Well Name: STEEL GUITAR 26-35

Sundry ID: 2830319

Type of Action: APD Change

Procedure Description: Devon Energy Production Co., L.P. (Devon) respectfully requests a name change and BHL move for the subject well (APD ID 10400083215). Devon also requests break test and offline cementing variances. Please see revised C102, drill plan, directional plan, and variance attachments. Permitted BHL: LOT 12, 1769 FNL, 630 FEL, 35-26S-29E Proposed BHL: LOT 12, 1768 FNL, 510 FEL, 35-26S-29E Permitted Well name: STEEL GUITAR 26-35 FED COM 415H Proposed Well name: STEEL GUITAR 35-26 FED COM 415H

Section 2 - Blowout Preventer Testing Procedure

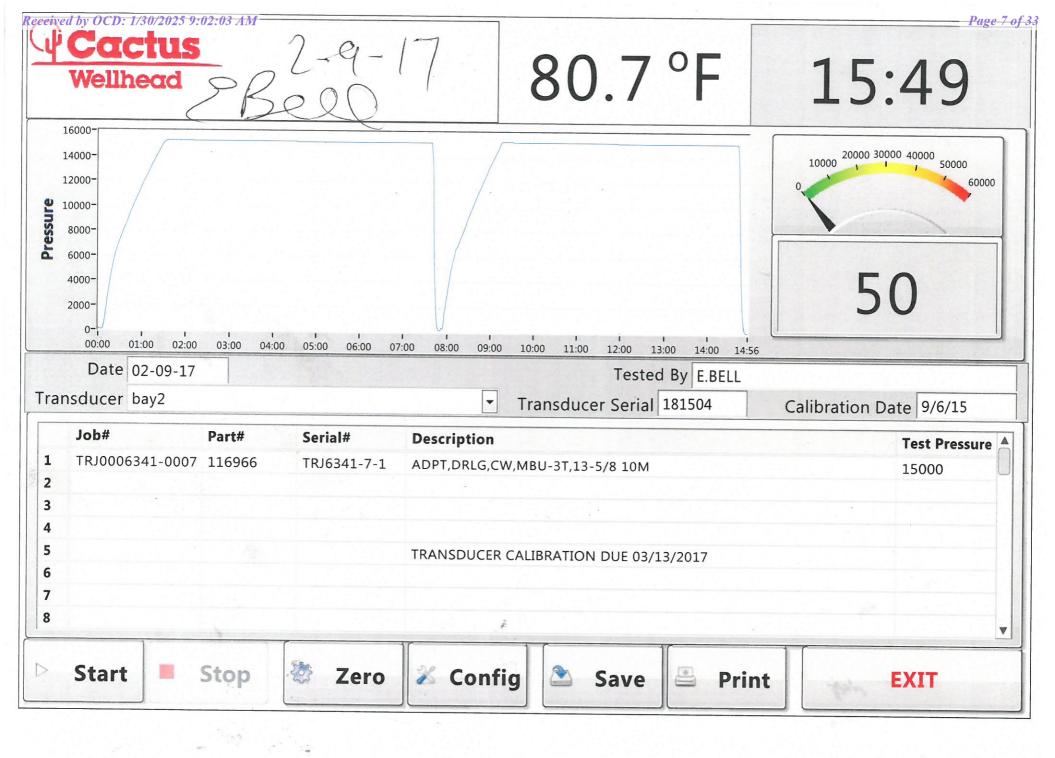
Devon Energy requests to only test BOP connection breaks after drilling out of surface casing and while skidding between wells which conforms to API Standard 53 and industry standards. This test will include the Top Pipe Rams, HCR, Kill Line Check Valve, QDC (quick disconnect to wellhead) and Shell of the 10M BOPE to 5M for 10 minutes. If a break to the flex hose that runs to the choke manifold is required due to repositioning from a skid, the HCR will remain open during the shell test to include that additional break. The variance only pertains to intermediate hole-sections and no deeper than the Bone Springs Formation where 5M BOP tests are required. The initial BOP test will follow 43 CFR 3172, and subsequent tests following a skid will only test connections that are broken. The annular preventer will be tested to 100% working pressure. This variance will meet or exceed 43 CFR 3172 per the following: Devon Energy will perform a full BOP test per 43 CFR 3172 before drilling out of the intermediate casing string(s) and starting the production hole, before starting any hole section that requires a 10M test, before the expiration of the allotted 14-days for 5M intermediate batch drilling or when the drilling rig is fully mobilized to a new well pad, whichever is sooner. We will utilize a 200' TVD tolerance between intermediate shoes as the cutoff for a full BOP test. The BLM will be contacted 4hrs prior to a BOPE test. The BLM will be notified if and when a well control event is encountered. Break test will be a 14 day interval and not a 30 day full BOPE test interval. If in the event break testing is not utilized, then a full BOPE test would be conducted.
